# UNITED STATES PATENT AND TRADEMARK OFFICE

APPLICATION NO.	FILING DATE	FIRST NAMED INVENTOR	ATTORNEY DOCKET NO.	CONFIRMATION NO.
10/801,544	03/17/2004	Kazuhisa Fukushima	042187	2323

## Office Action Summary

## **DETAILED ACTION**

FIG.3

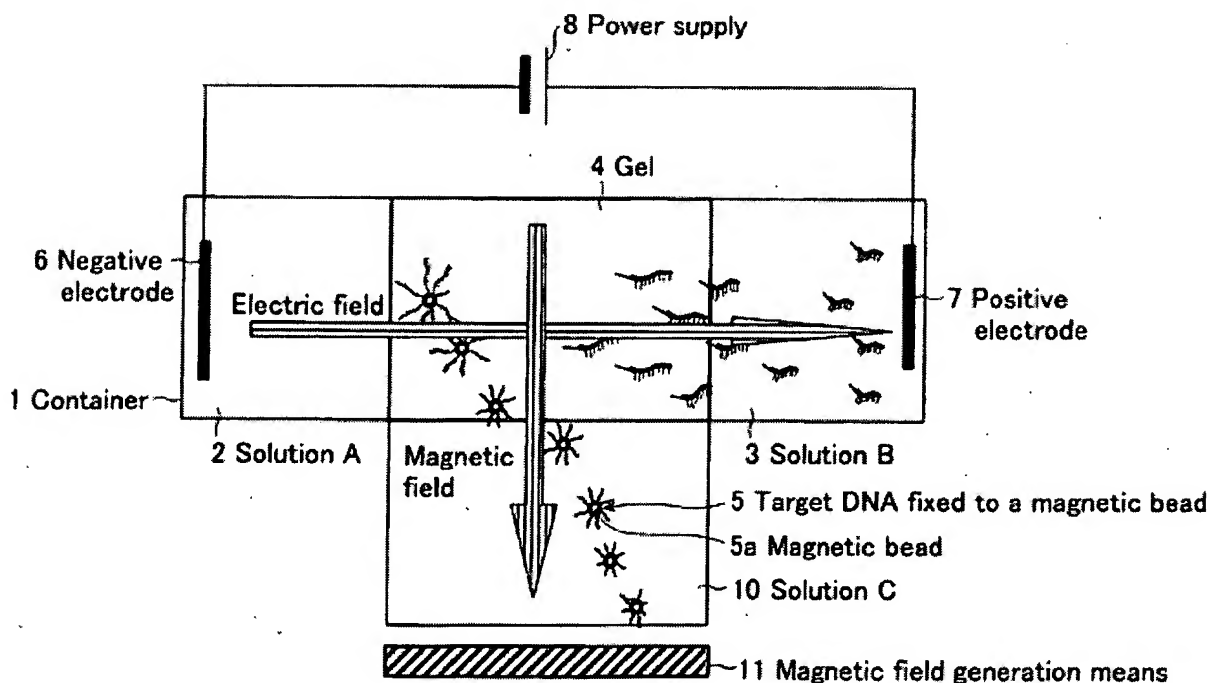
7. Acknowledgement is made of the figures depicting a device performing electrophoresis (see Figure 3, below) and that the surface of the device does occupy an "area," however, such illustrations do not identify "a gel, a pillar array, or a porous filter" as being a first or second area.
